Address to City Council
April 10, 2013

RE: Impact to Sequoia grove at Pier Park from new trail spur

Request of Chris Fountain to address Council regarding the trail off the Chimney/Pier Park bridge and the Giant Sequoia Grove (Communication)

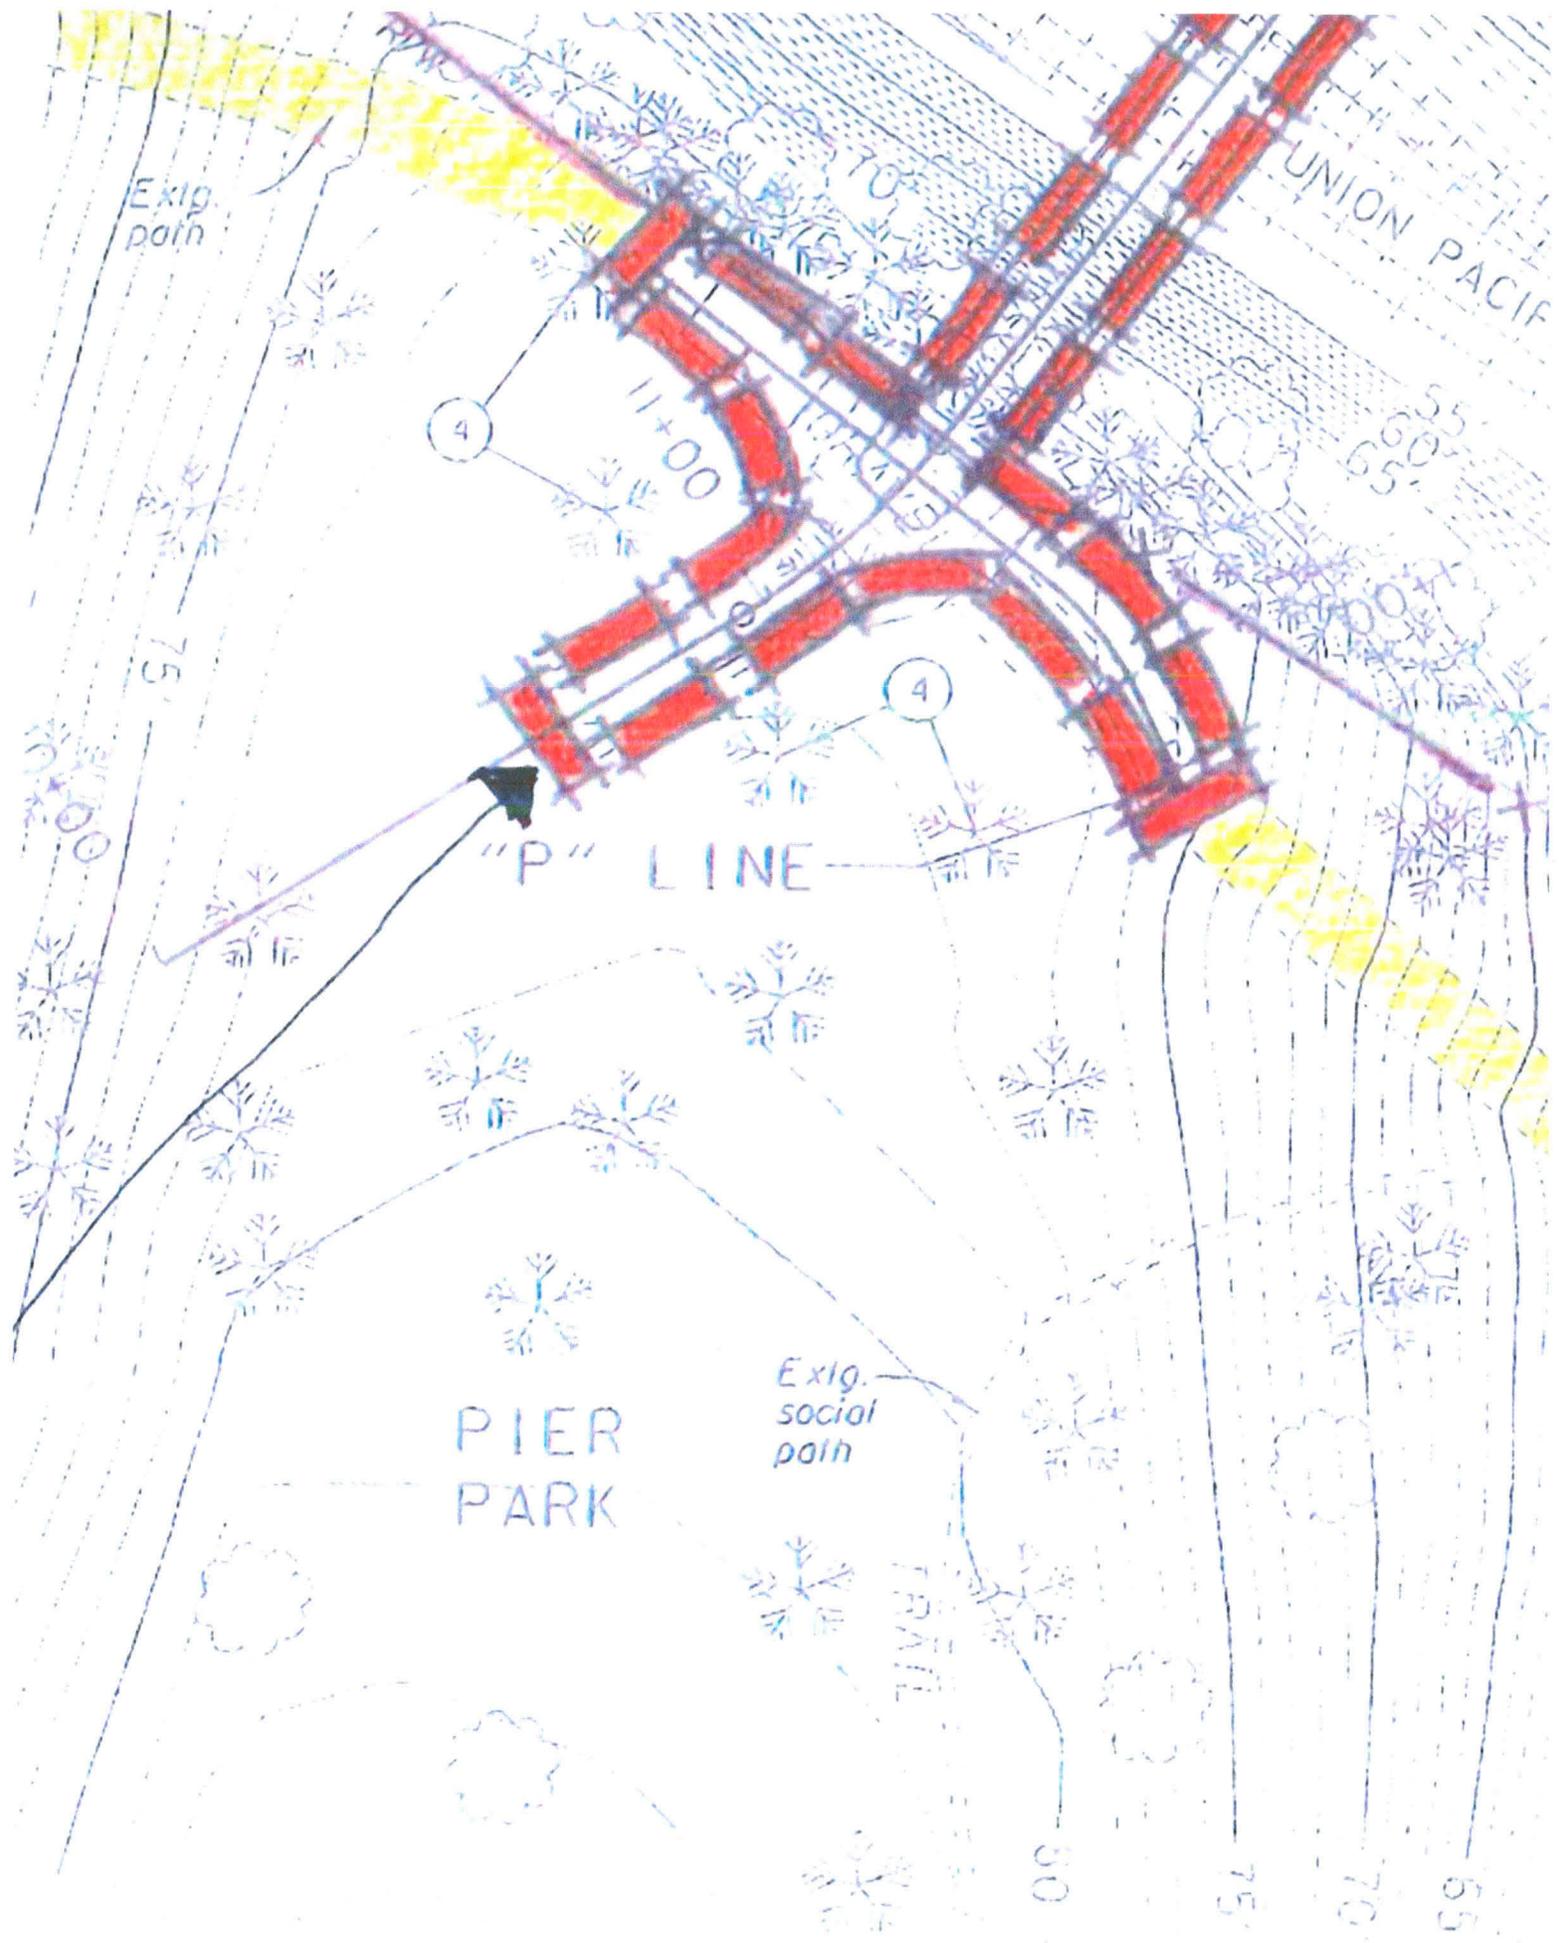
There has also been much rhetoric about the fact that the 65' section is what makes the bridge ADA compliant, and that it's inclusion was required in order to have the project funded. If ADA compliance is important, consideration needs to be given to the following:

- Until this trail section becomes a part of a complete trail through Pier Park, this 65' is **NOT** ADA compliant, because it not accessible from Pier Park. If ODOT considers a dead end 65' trail section a compliant ADA trail, this is an insult to the ADA community. Parks has repeatedly stated that there are no plans to build a continuation of this section for many years.

Plan section taken from
North Portland Greenway Trail Section 2
<http://www.portlandoregon.gov/parks/article/429521>

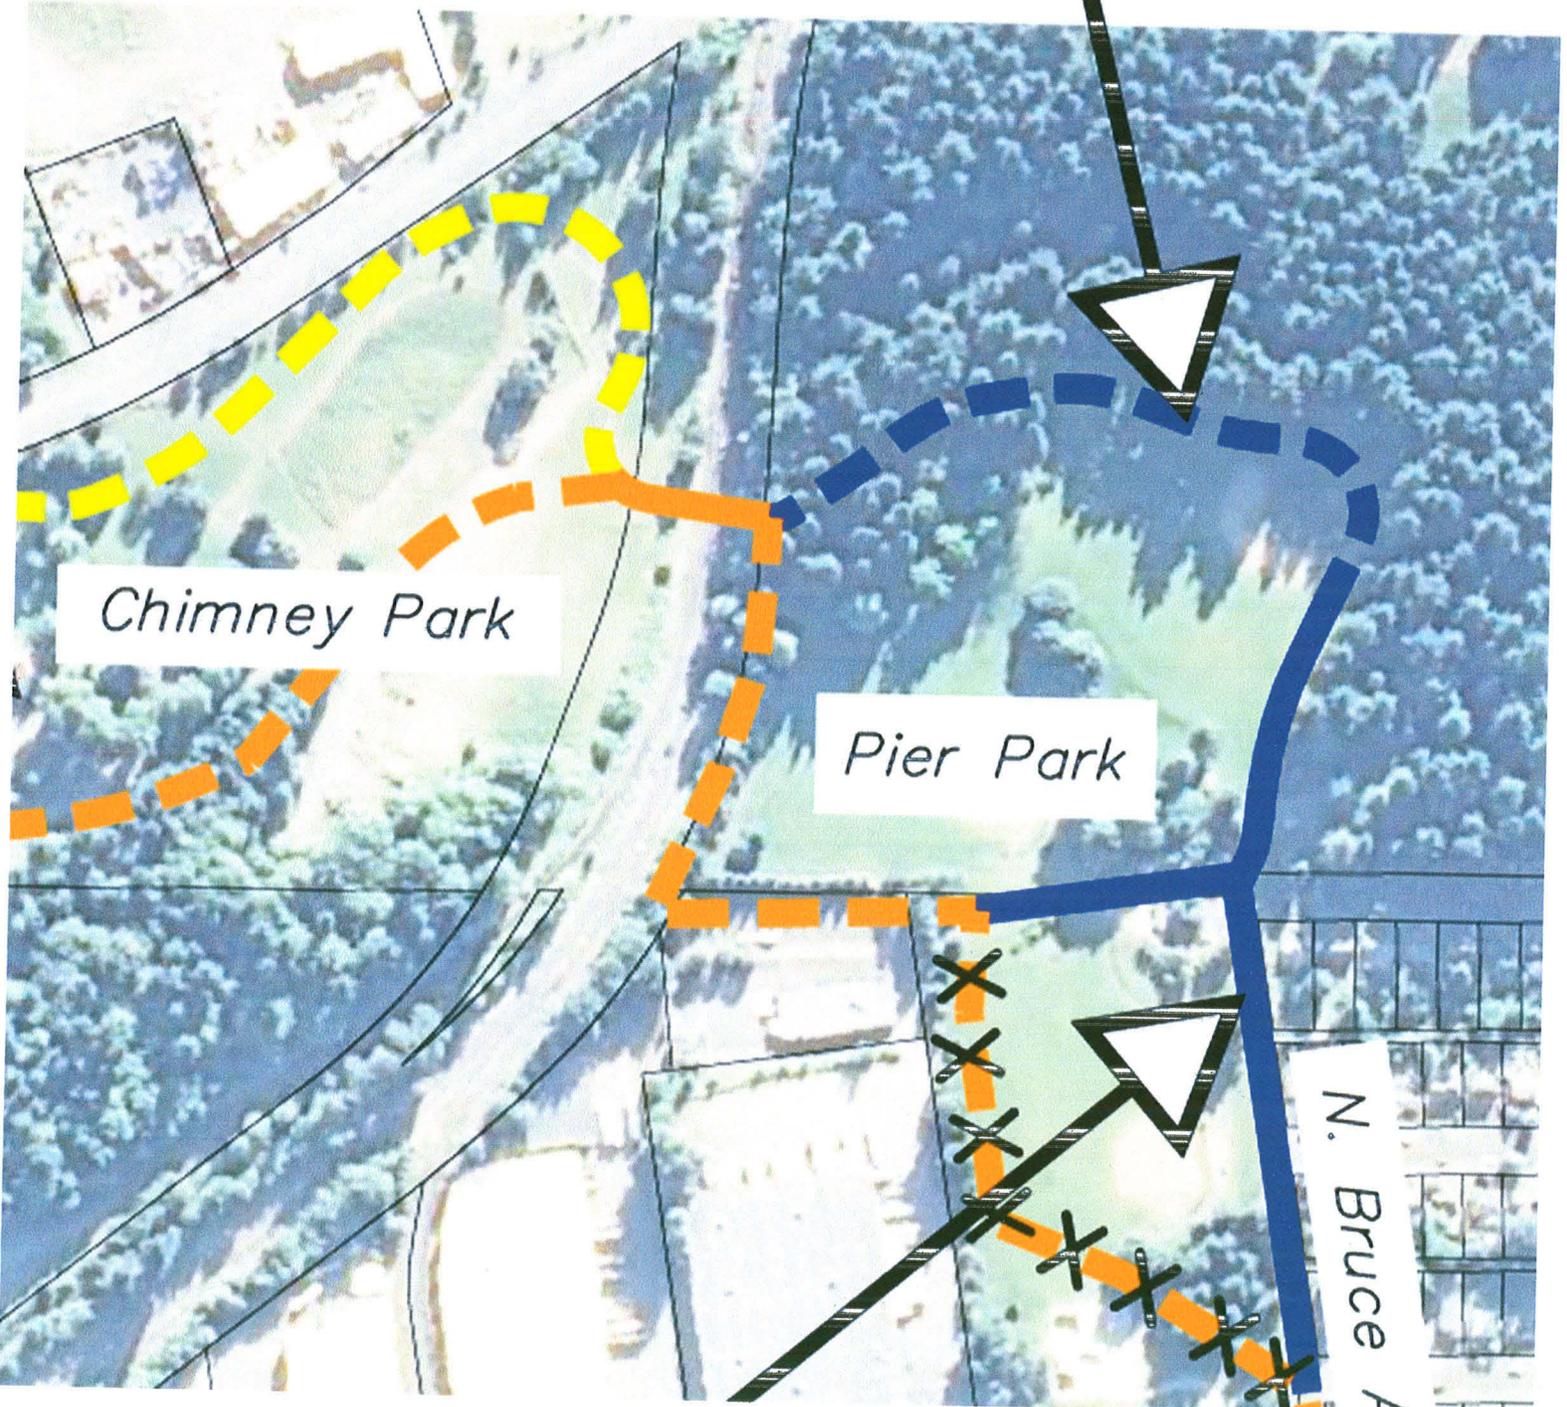
We have statements from several people who are particularly interested in the preservation of the trees in Pier Park who were in attendance at this meeting. These people state that they didn't see any drawings that night that indicated a sequoia tree was going to be removed, or that there would be a 65' trail section that would extend from the bridge into the sequoia grove.

Most park users were totally unaware that the tree would be removed until a sign was posted in the grove 10 days before it was removed, and were totally unaware of the impact that the 65' trail section would make on the grove.

8' ADA accessible trail.
